Adequacy Review No. 1, TR-7, Home Office Mine, M1977-439

EXISTING CONDITION FLOODPLAIN AND FLOODWAY WORKMAP

MARTIN MARIETTA MATERIALS TAFT HILL SITE

Figure 2.pdf
4847K

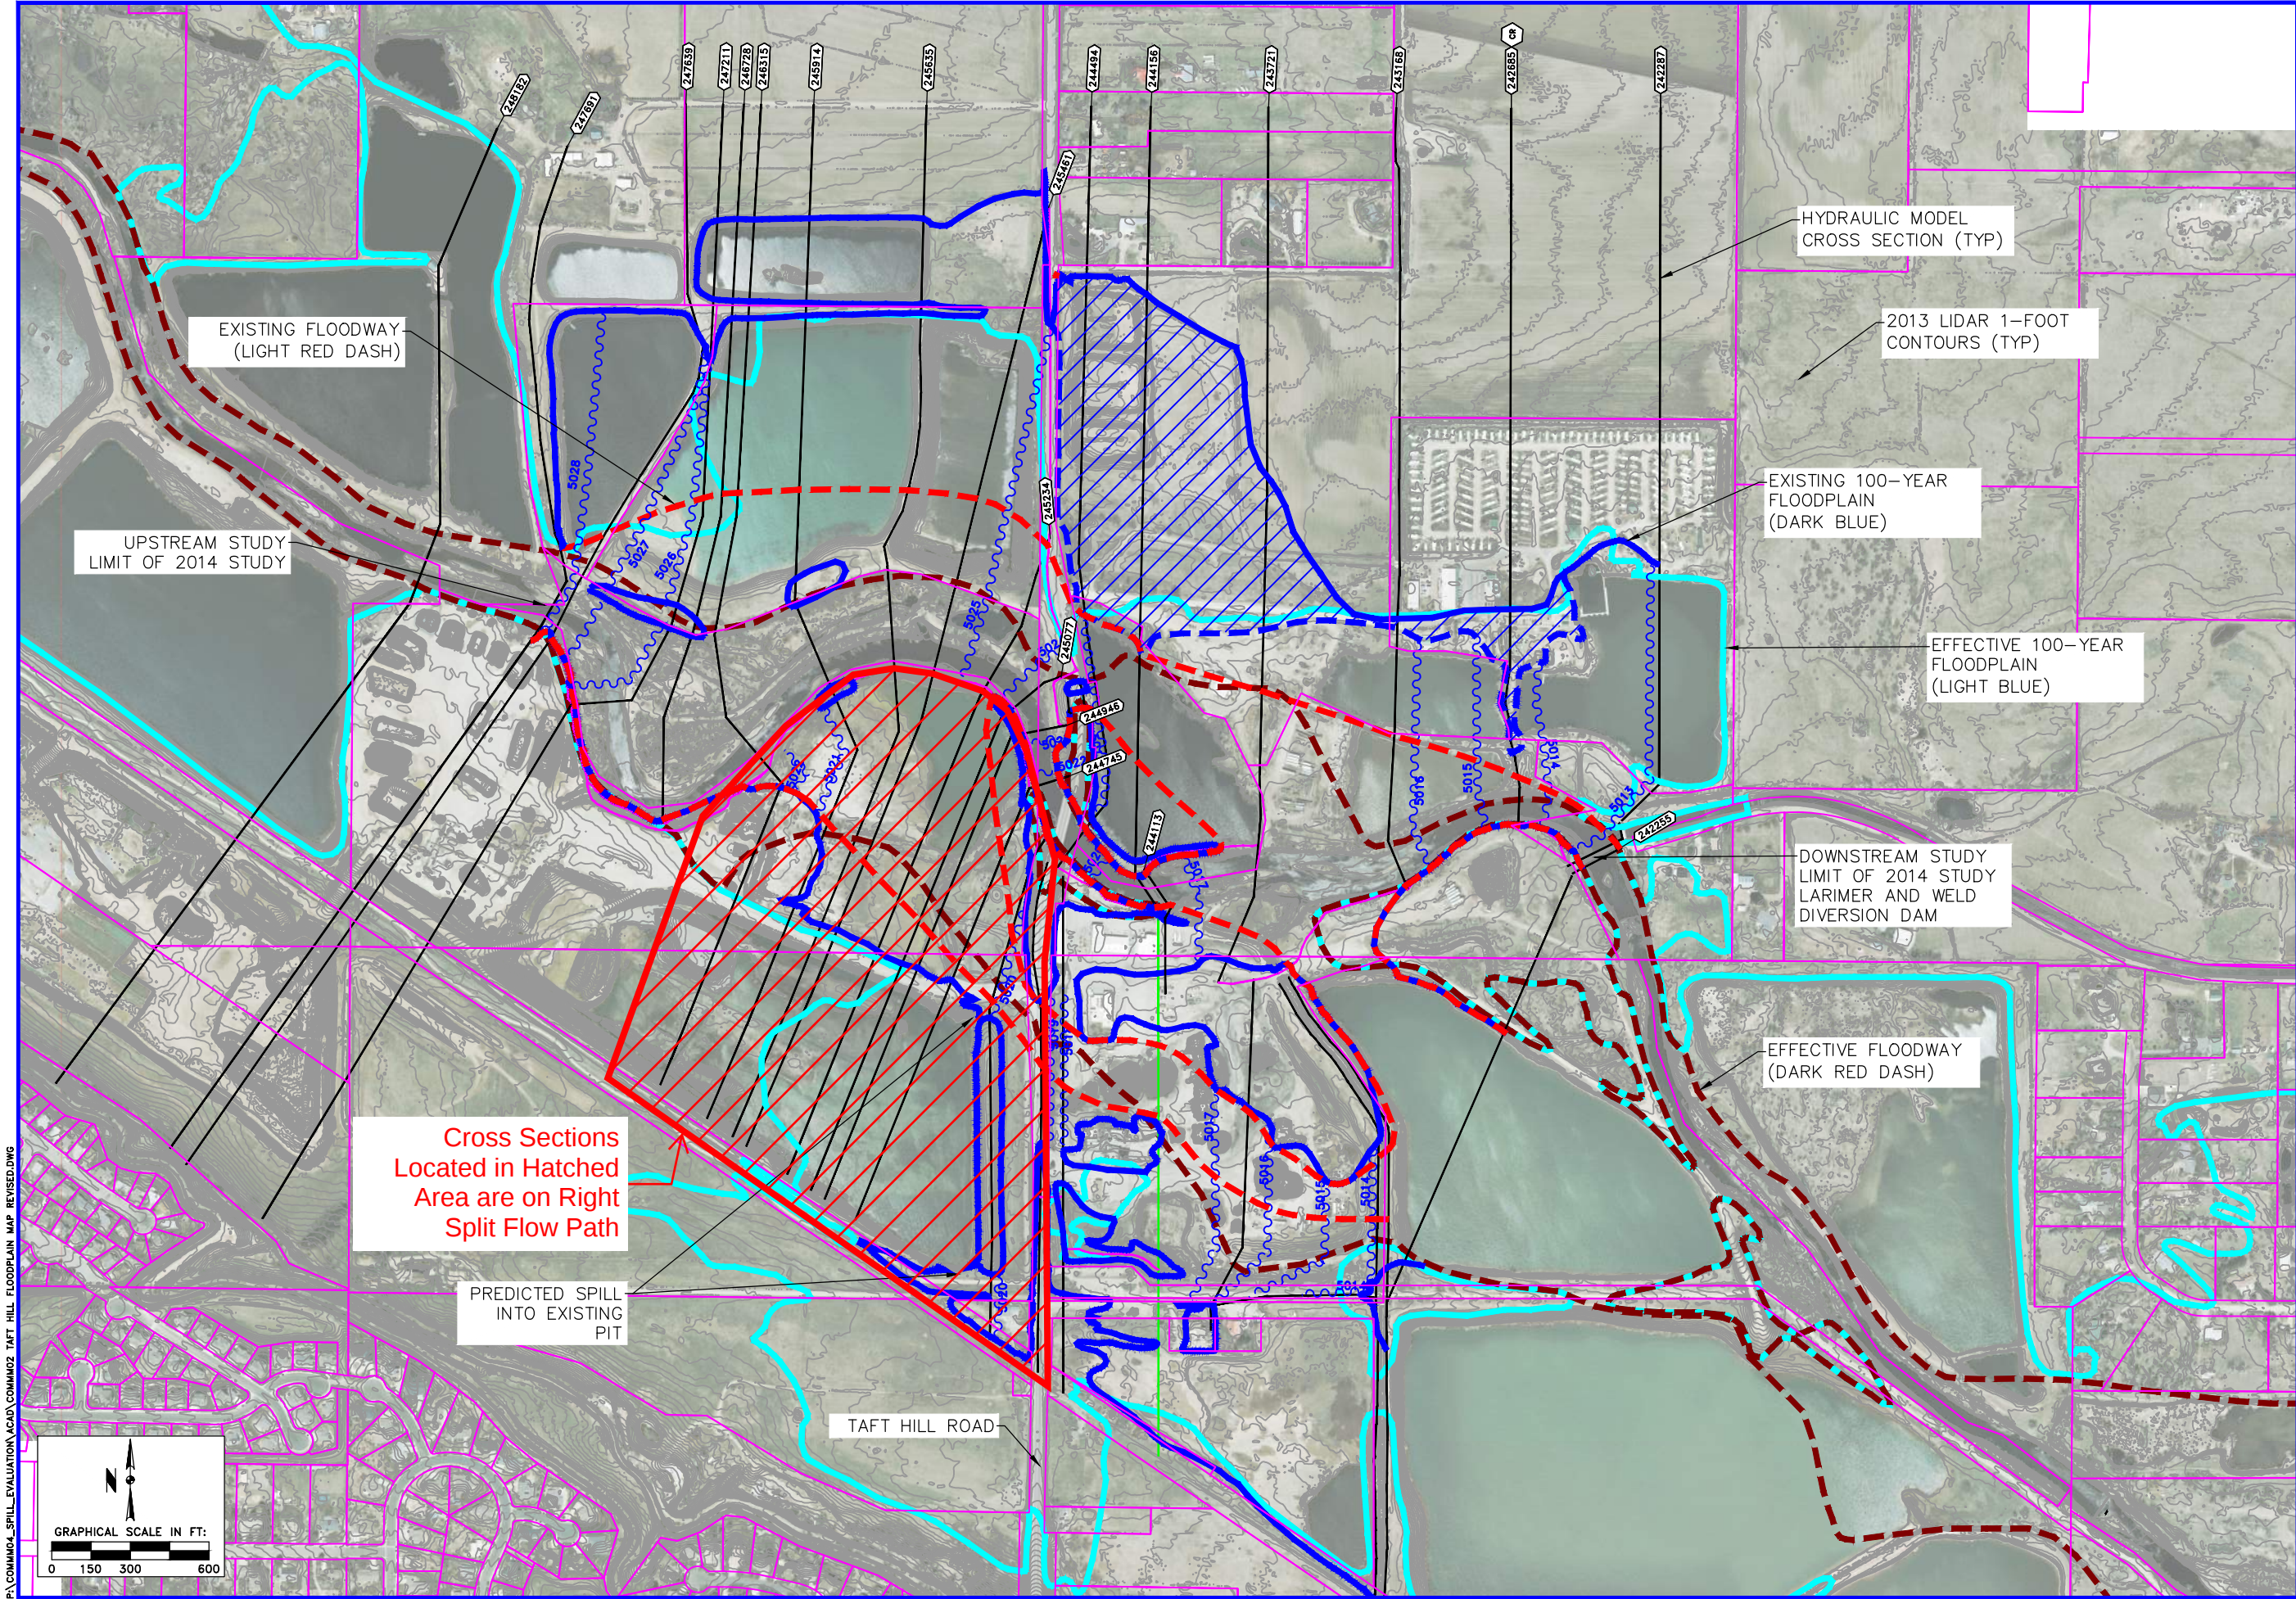
- Comment #1:
 - As discussed in the submitted technical memo, two sets of hydraulic models were utilized for the analysis. A one-dimensional model with cross sections was prepared back in 2014-2015 using HEC-RAS Version 4.1. Cross Section print outs from this model are attached with annotation noting which ones are Sections CV, CW, and CX. Please note that the 1D model utilized split flow paths, so cross section print outs are provided for both the main channel and right split flow path. The cross section numbers noted on the attached pdfs correlate to those shown on Figure 2 in Attachment C of the memo. This figure has been attached to this e-mail for reference and has been annotated to show which cross sections are contained along the Right Split Flow Path.
